SUBJECT: CUMBERLAND STEAM PLANT - ANNUAL POWER ENGINEERING AND CONSTRUCTION AND FOSSIL AND HYDRO POWER JOINT INSPECTION OF THE ASH DISPOSAL AREA

CUMBERLAND STEAM PLANT

ASH DISPOSAL AREAS

TITLE CUMBERLAND STEAM PLANT - ALL UNITS - ANNUAL JOINT INSPECTION BY THE DIVISION OF POWER ENGINEERING AND CONSTRUCTION AND THE DIVISION OF FOSSIL AND HYDRO POWER		REPORT NO. FEP-ASH-88-01	
		PLANT/UNIT CUF-ALL UNITS SAR SECTIONS	
VENDOR	CONTRACT NO.	KEY NOUNS	
			UNID SYSTEM(S)
	REV	(FOR RIMS USE)	RIMS ACCESSION NUMBER
	R0		B65 '88 0406 001
APPLICABLE DESIGN DOCUMENTS	R1		
	R2		
REFERENCES	R3		
	R4

④ *WELLS CREEK CHANNEL  
RED WATER SEEPAGE*

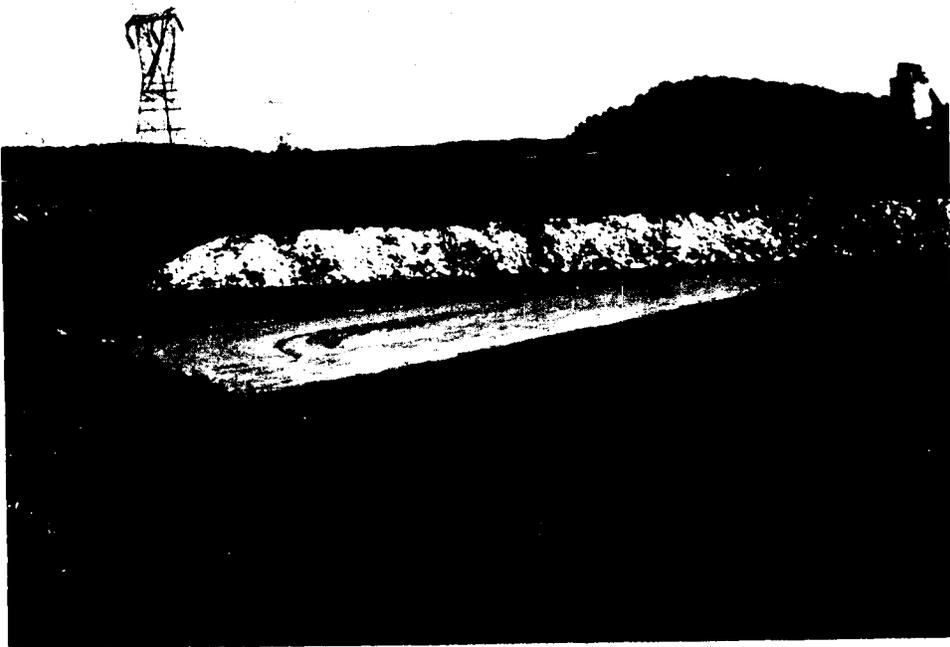
- 2.1 This inspection continued to show several wet areas in the vicinity of the construction haul bridge along the bank of Wells Creek, which was at low pool. There was no apparent change in the amount of seepage, although a significant amount of redwater seepage has appeared (see recommendation No. 1). Also, there were no apparent signs of instability anywhere along either slope of the dike.
- 2.2 The south-southeast (S-SE) dike evidenced the encroachment of "rose bush" vegetative growth and other small bushes (see recommendation No. 3). The grass cover in general is good; however, some small local areas need to be addressed (see recommendation No. 4).
- 2.3 The dike roadway has an excellent crushed stone surface.

③ *DIKE ROADWAY  
EXCELLENT CRUSHED STONE SURFACE*

- 6.2 With the bottom ash dike in place and the stilling pool water level at elevation 368, the seepage along Wells Creek remains at a reduced level. However, there is seepage along the creek and as the stilling pool level is increased to elevation 373, the seepage along the creek will likely increase. F&H PR should consider budgeting funds in the next two years to repair the exterior dike with a slurry trench.

46 C 4 10N212

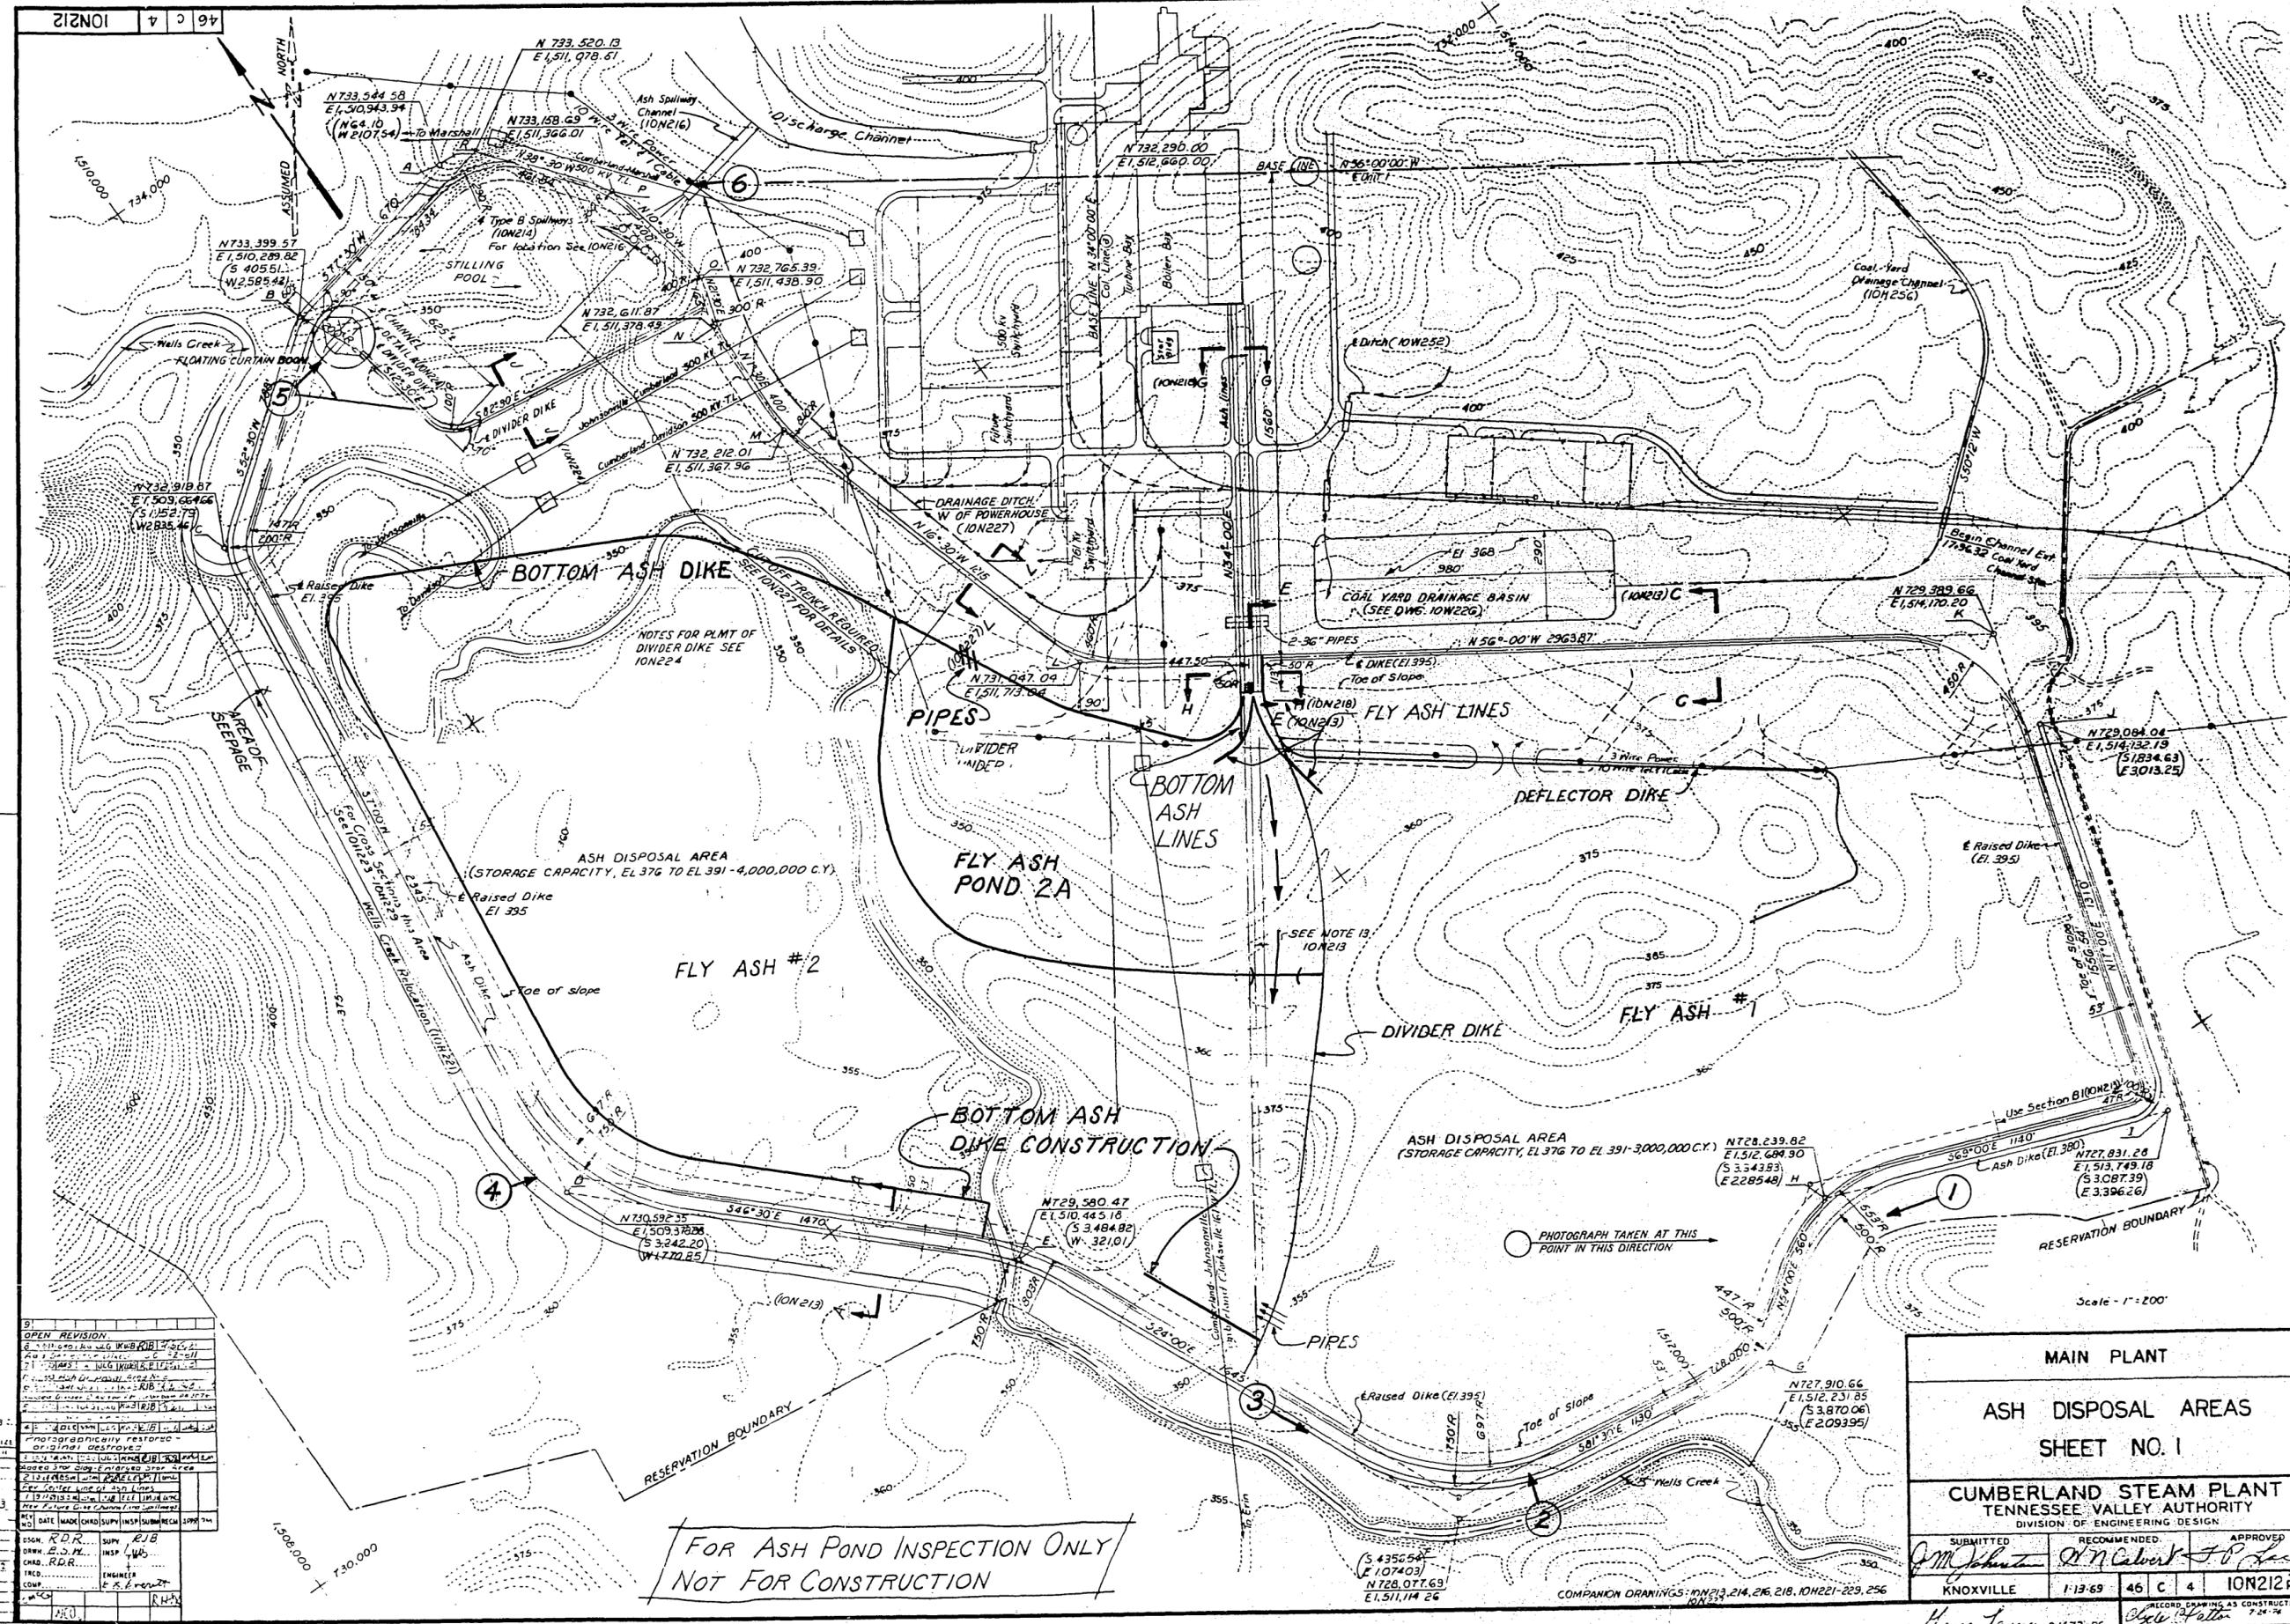
- 3.1 Area No. 1 has been sluiced full of fly ash with approximately 30 percent of this area covered with water. This area is no longer being used for the sluicing of fly ash.
- 3.2 The fly ash is presently being sluiced into area No. 2 through a breached dike in area No. 2A (see attached drawing 10N212).
- 3.3. The construction of the interior bottom ash dike for area No. 2 continues and is approximately 90 percent complete to elevation 373+. This dike serves to decrease the waterhead against the exterior dike so as to ensure stability of the exterior dike (see recommendation No. 1).
- 3.4 All sluice water continues to flow to the stilling pool via flow through spillway with a floating skimmer, with an additional floating skimmer directly in front of the standard spillways. All discharge is directed to the plant discharge channel.
